# EXHIBIT O

Subj: Poulsbo Meadows Development concern on adjoining neighbors

Title: Enclosure (1) - Commentary regarding the Principal concerns for the Poulsbo Meadows Residential Development

Re: Poulsbo Meadow's PRD/Plat,  
Preliminary Plat Drawings & Neighborhood Concerns

**Photo 1:** Golden cypress on the north property line, north of the home.

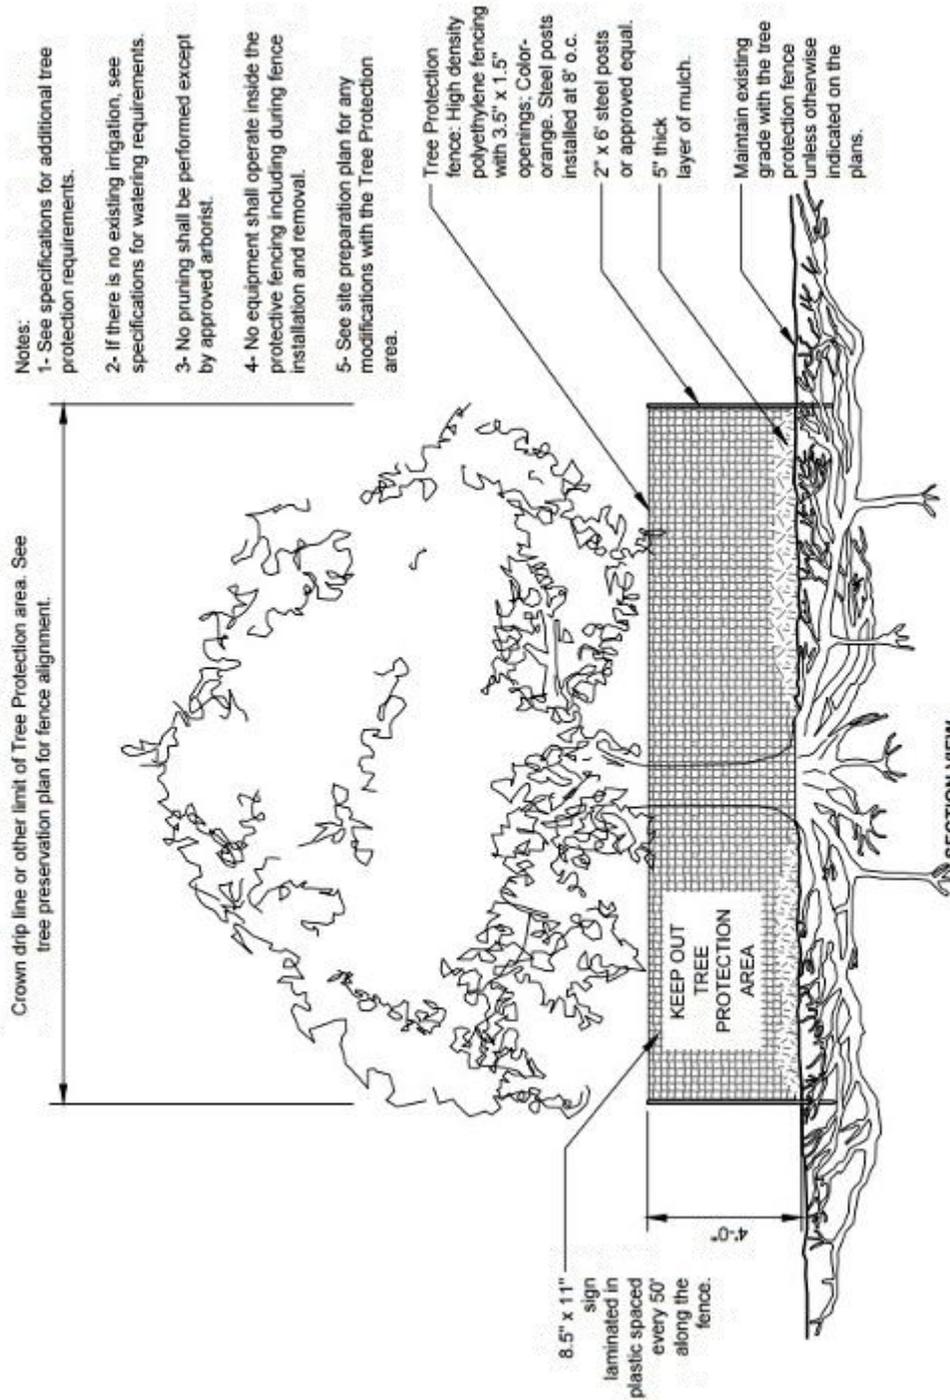
- 1) Tree 1: Golden cypress (*x Cupressocyparis species*) (Photo 1) – 17” diameter at breast height (DBH). This ornamental tree grows just south of the assumed north property line. It has a drip line consistent with the species of approximately 20’. This tree is in very good condition with no apparent structural or health defects.

If this is the case, between 40-50 percent of Trees 1-3 critical root zones will be significantly and negatively affected. Removing or damaging roots or clearing or removing soils within critical drip lines of these three trees would severely impact their vigor and stability. Targets in the event that any tree failed in their root zone are Ms. Lau and Mr. Williams’s home, garage, other good condition trees and back yard. Since prevailing winds in the Poulsbo area can arise from the north, the trees failing after root disturbance could be considered a high probability.

It is my professional opinion that unless development activities remain outside of the drip line of all three trees that decline and instability will become nearly immediately evident.

ATTACHMENT 1 – Curtain Drain Recommendations

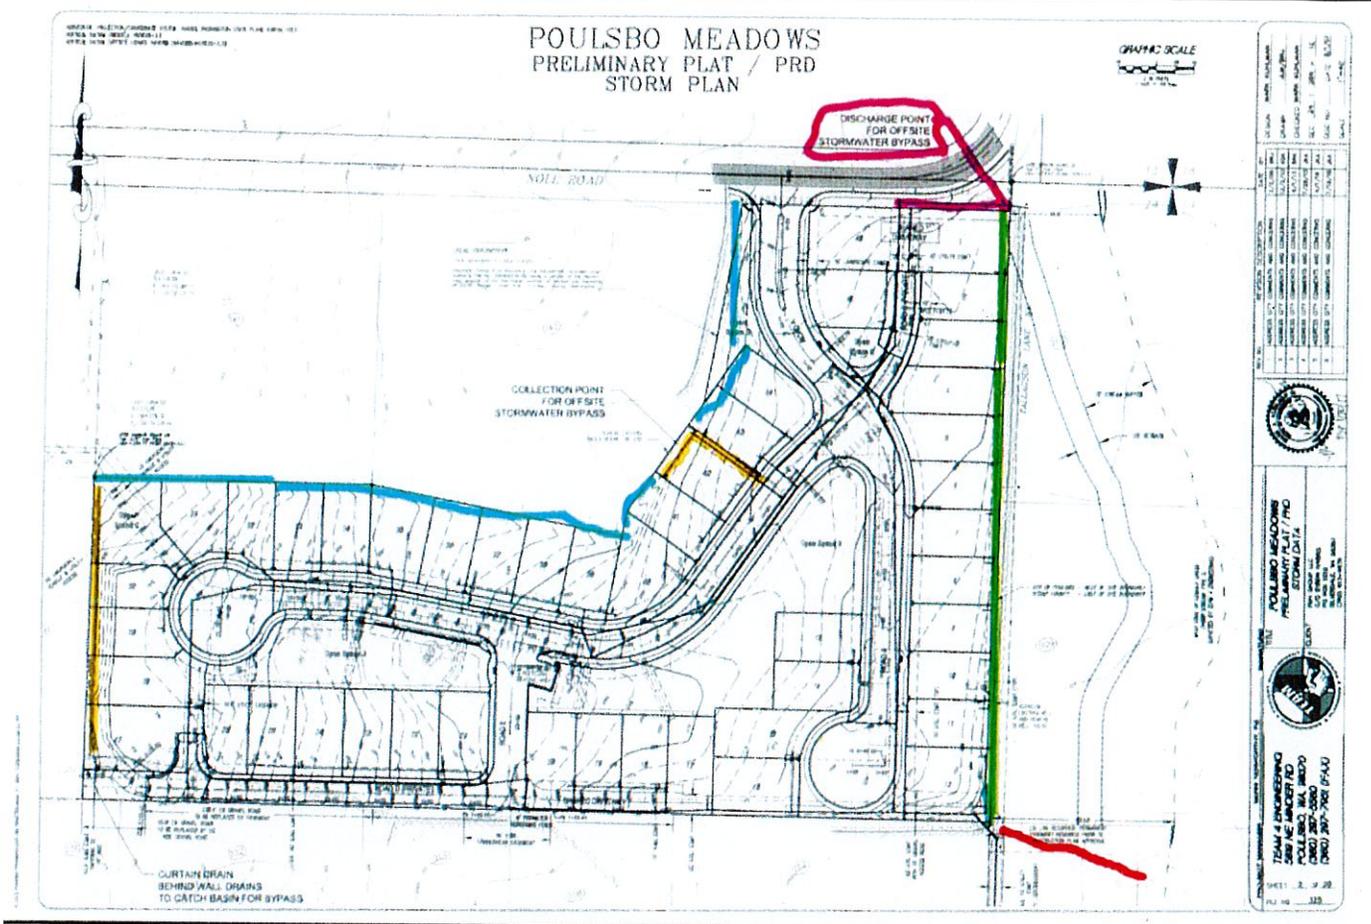
a. Current stormwater plans do not account for the realistic surface water runoff, and only show two curtain drains. Per the current landowners, water runoff streams off both the 041 and 042 parcel property lines as shown in Attachment 1. We request a review and reassessment be done to ensure this water runoff is bypassed back into Lemolo Creek and the surrounding wetlands, and recommend a curtain drain as highlighted in blue in Attachment 1 (The existing proposed curtain drain is highlighted in yellow).

b. Current stormwater plans do not show the drainage ditch along Tallagson Ln (Attachment 1, highlighted in green). Further, the elevation descriptions suggest the ditch will be filled. The current plan also does not depict the culvert that starts at the southeast corner of the Poulsbo Meadows property and runs underground to Lemolo Creek, surrounding wetlands, and the pond on Barbara Maxey's property. (See Attachment 1, highlighted in Red). This culvert is missing from the document submitted by Berni Johnson of Team 4 Engineering dated Jan 4, 2008, titled Review of Proposed Storm Detention Plans for Poulsbo Meadows and Mountain Aire Projects. We request a third-party review of the plans and a reassessment be done on the impacts to the pre-development hydrology of Lemolo Creek. In addition, we request that impacts to both the Critical Aquifer Recharge areas and surrounding wetlands on the Zapata and Maxey properties be evaluated and documented. (This is reiterated in Item 4 below.)

d. The stormwater plans show the outlet for the bypass system to be at the NE corner of the Poulsbo Meadows parcel (see Attachment 1, highlighted in purple). This corner of the property currently is much higher in elevation, and thus does not see much water runoff. However, the current stormwater plans show the bypass system outlet here, and thus would cause a significant variation to the drainage ditch, with impacts requiring assessment. As well, Team 4 noted that the ditch in the NE corner was dry, and most of the runoff was seen 30' or so south of this corner. (See Attachment 2, highlighted in green.) We request a review and redesign of the stormwater plans to ensure that the system does not cause negative impacts to the maintenance of Tallagson Ln, and neighboring properties.

An extensive storm drainage system will be constructed throughout the project to direct stormwater to an existing stormwater quantity and quality facility within the Mountain Aire PRD/Plat along with directing stormwater to Lemolo Creek to meet existing flow conditions. Stormwater will be collected within the development along with 2.5 acres west of the property and direct it to the existing facility. Storm drainage will also be provided to collect stormwater from the 6.8 acres north and northwest of the property and direct it to the existing culvert at the southeast corner of the site. This area is tributary to the existing culvert by sloping to the drainage ditch along Tallagson Lane. With the development of the Poulsbo Meadow's PRD/Plat, peak flows rates and stormwater volumes directed to the existing culvert will be reduced slightly but similar to the existing conditions. The owner of Poulsbo Meadow's is willing to work with the property owner to increase the capacity or clean the existing culvert as necessary with this development.

Curtain drains have not been show in the preliminary plat drawings. Curtain drains will be shown as necessary with the construction drawing to protect proposed houses or direct stormwater to bypass catch basins. The preliminary plat drawings show many catch basins to connect curtain drains as necessary to direct stormwater to the Mountain Aire stormwater facility or the bypass storm drainage system.
